Appl. No. 10/620,309 Proposed Amdt. 2/2/05

Amendments to the Drawings

ANNOTATED SHEET Serial No. 10/620309

FIG. 11A

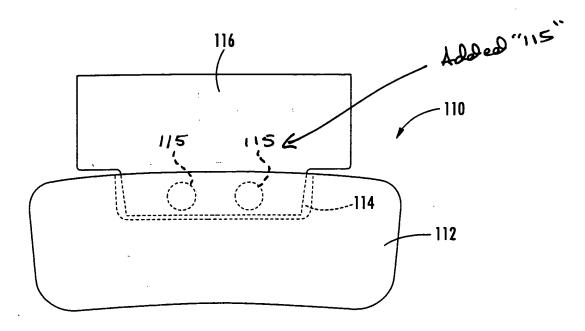
Changes to sheet 12/15 of the drawings are being made by the present amendment. Specifically, Fig. 11A has been amended to add reference number "115." Similarly, Fig. 11B has been amended to add reference numbers "115" and "117."

By the above amendment, the paragraph appearing at Page 10, lines 24-32 has been amended to specifically describe the hump 117. In addition, this paragraph has been amended to include an express reference to holes 115, which are provided in the attachment portion of spring clip 116 to facilitate attachment. A corresponding amendment has been made to Figures 11A and 11B.

FIG. 11B

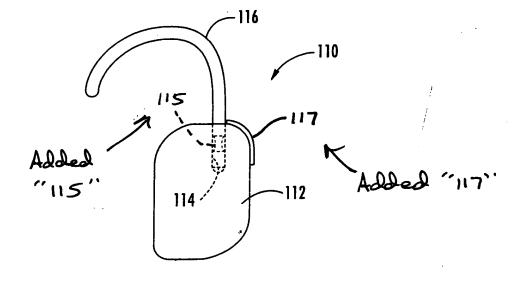
The Examiner objected to the drawings on the basis that it is "unclear what the unlabeled element located on the balance weight adjacent to the clip in Figure 11B represents with regards to the invention." As discussed to some extent in the interview, the unlabeled element is a "hump" that results from the manner in which the wheel weight in Figure 11B is preferably formed. As is apparent from the discussion in relation to Figures 9-10 and 11A-B, the mass portion 112 is preferably cold formed of nonlead material. A clip securement cavity is formed fitted inside the body of the weight. When the attachment portion of the spring clip is inserted into the clip's securement cavity, it is closed so as to attach the spring clip. Because of the thickness of the attachment portion of spring clip 116, hump 117 remains.
